SYNOPSIS OF PROPOSED REVISIONS
HOUSTON CWSP
NOVEMER 2025

Houston County - Countywide Safety Plan

Attachment C

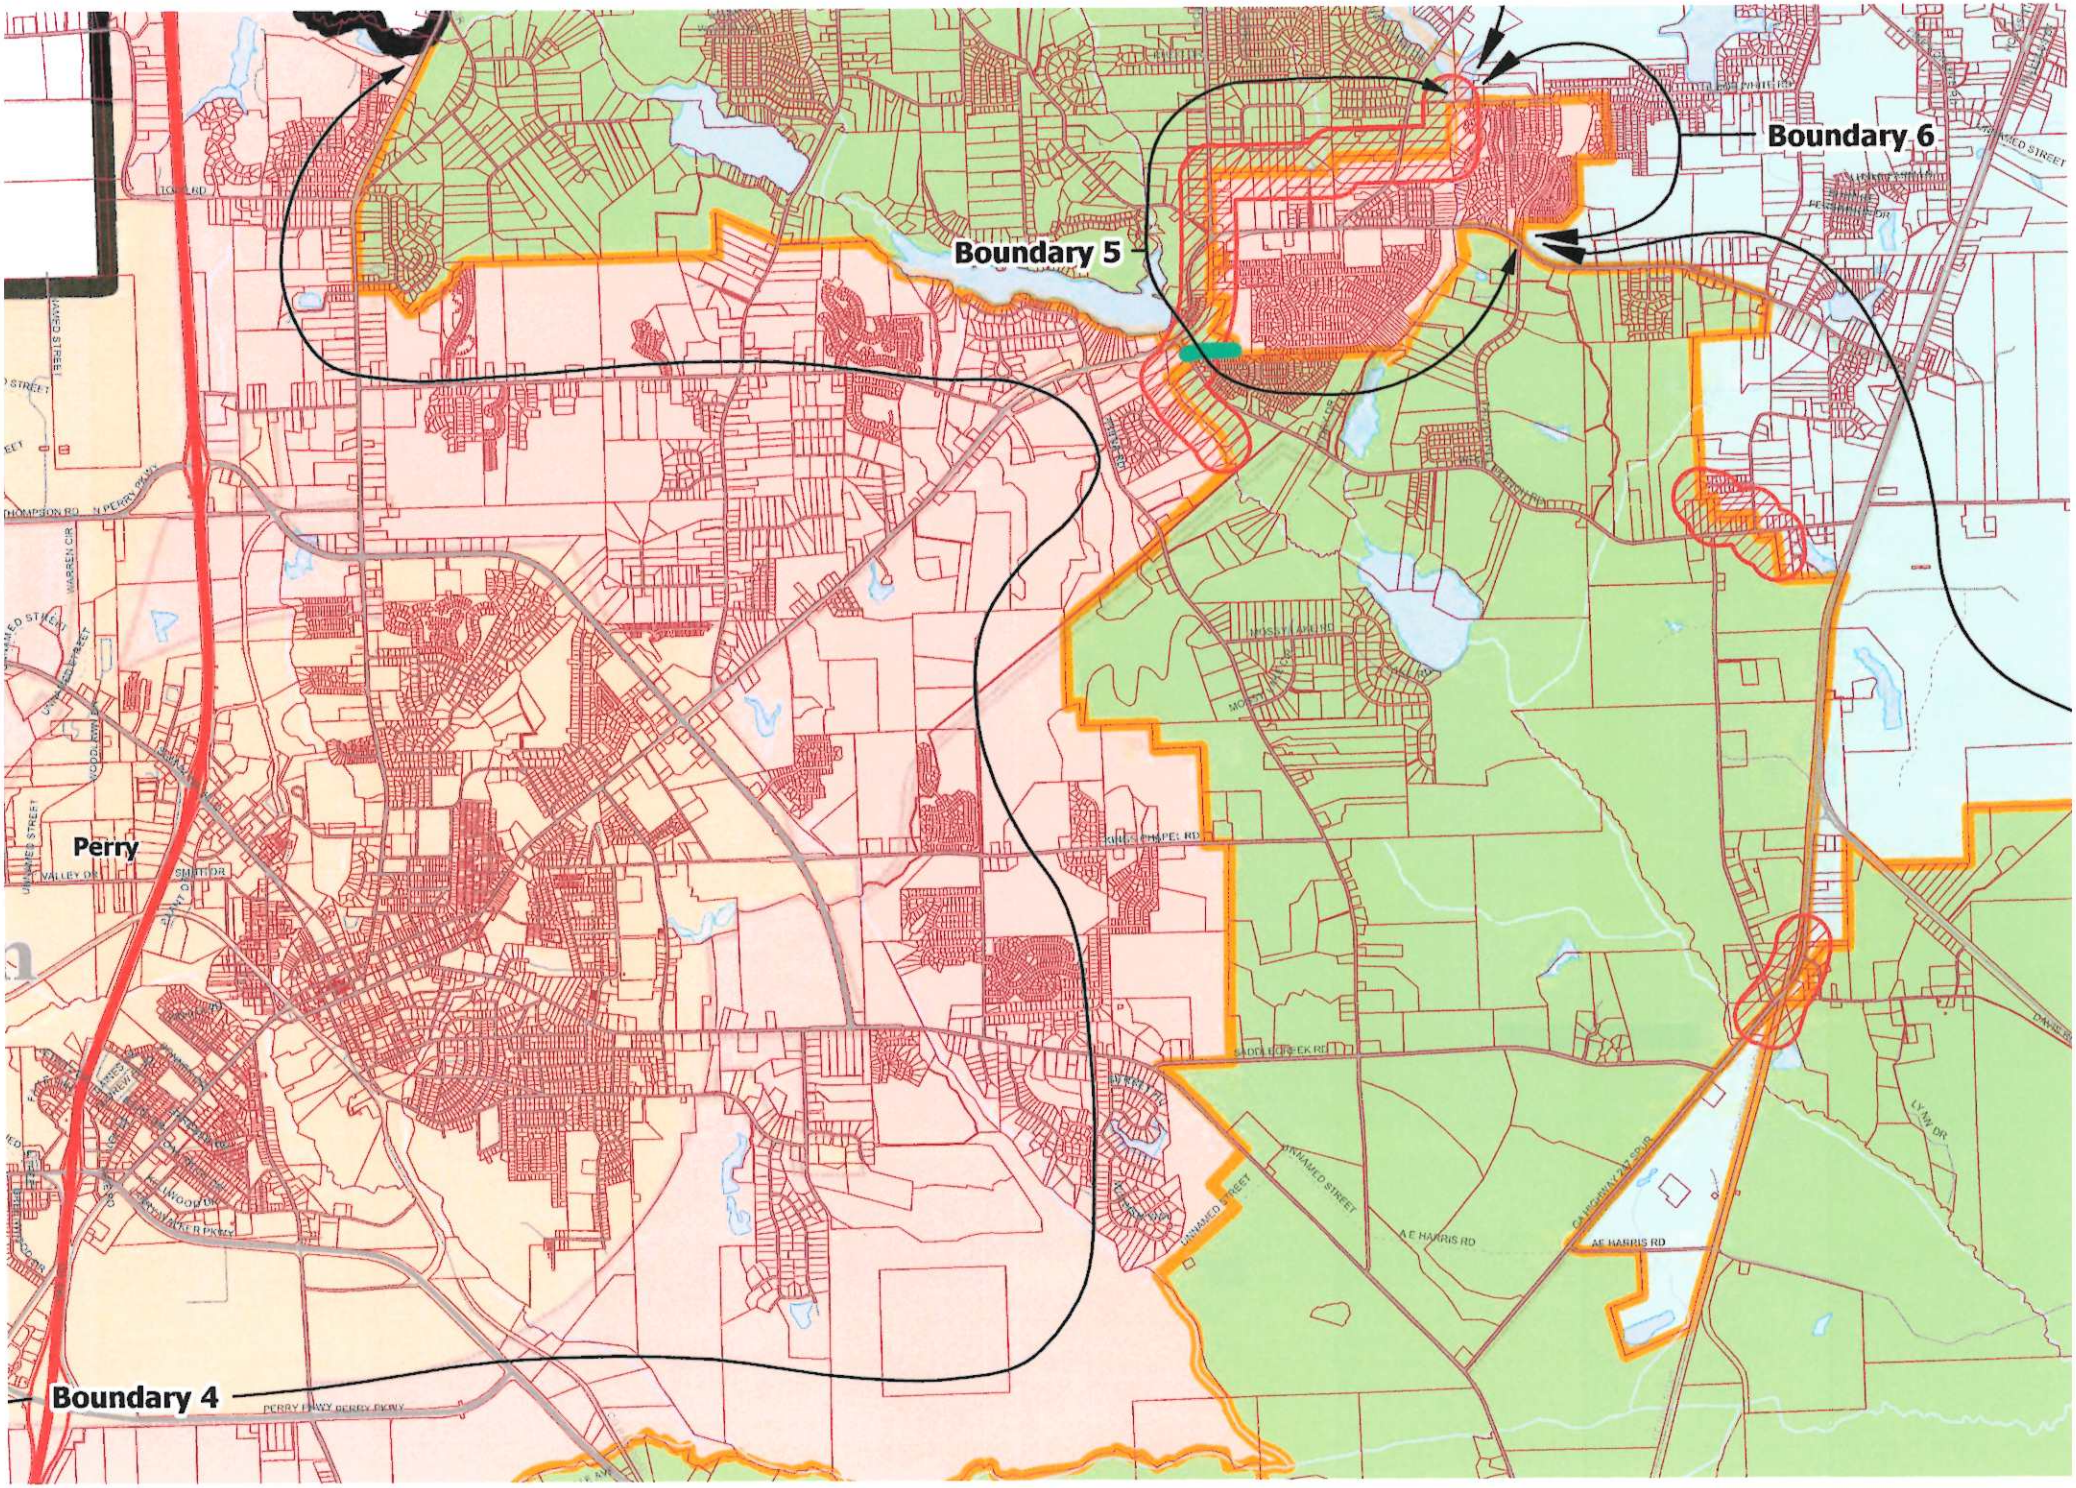
- The most significant Boundary revisions in the proposed Plan are limited to the area immediately east of Houston Lake in the center of the County.
    - In the current Plan, Perry's territory is contiguous and separates MSE's territory to the north and to the south with MSE having a Pipeline-Only Right-of-Way through Perry's territory.

- In the proposed Plan, territory in the vicinity of MSE's Pipeline-Only Right-of-Way will be transferred from Perry to MSE, separating a small area of Perry's territory to the east.

- The transfer of territory from Perry to MSE eliminates the need for MSE to have a Pipeline-Only Right-of-Way and creates the need for Perry to have a Pipeline-Only Right-of-Way in the transferred territory.

- The transfer of territory also significantly affects Boundaries 4 and 5, with the southern part of the current Boundary 5 becoming part of the new Boundary 4; and the eastern end of the current Boundary 4 becoming part of the new Boundary 5.

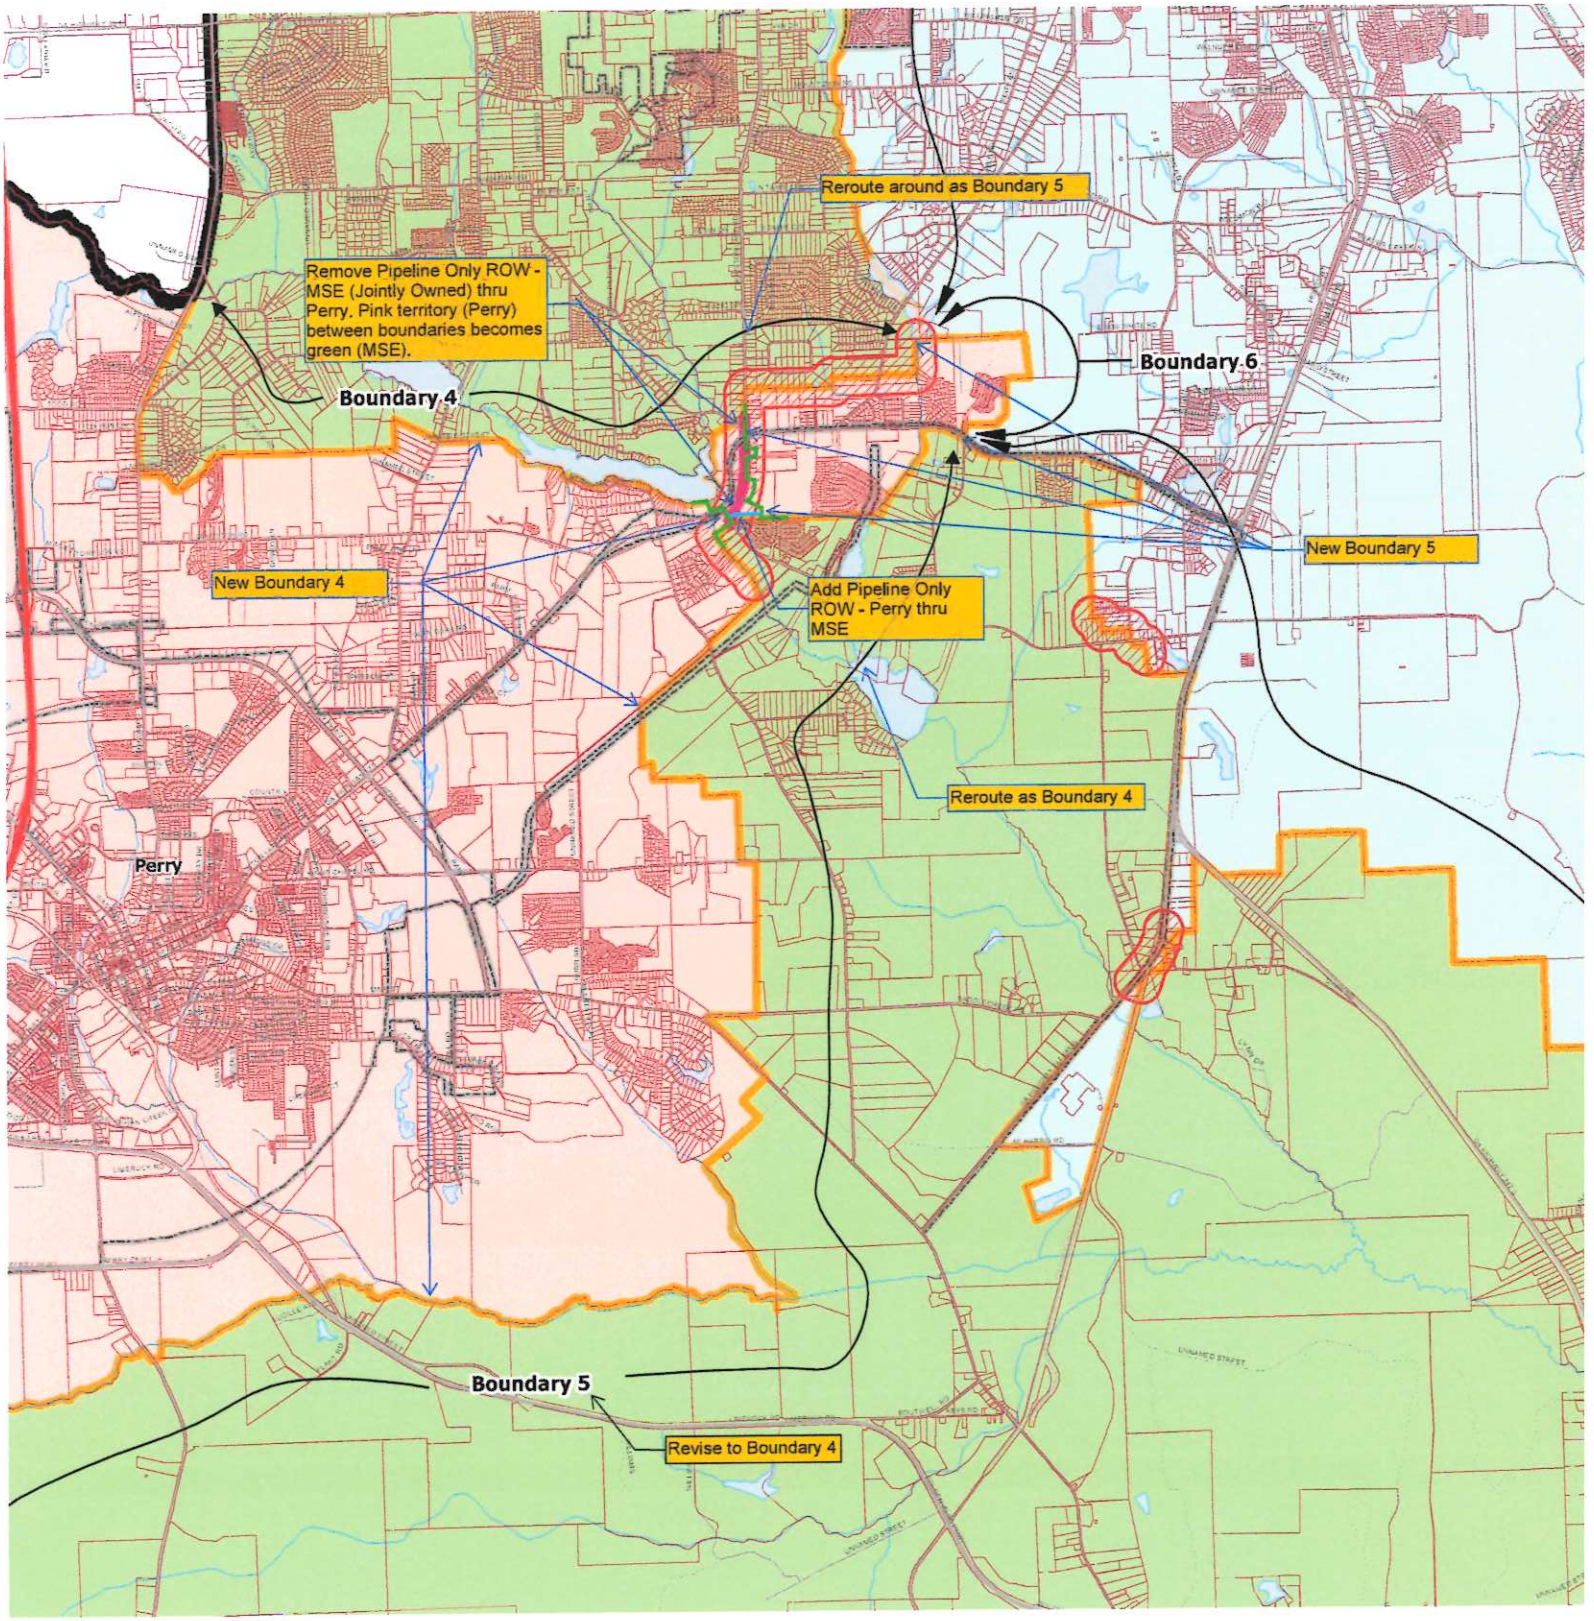
Reroute around as Boundary 5
Remove Pipeline Only ROW - MSE (Jointly Owned) thru Perry. Pink territory (Perry) between boundaries becomes green (MSE).
Boundary 4
Boundary 6
New Boundary 5
New Boundary 4
Add Pipeline Only ROW - Perry thru MSE
Reroute as Boundary 4
Perry
Boundary 5
Revise to Boundary 4
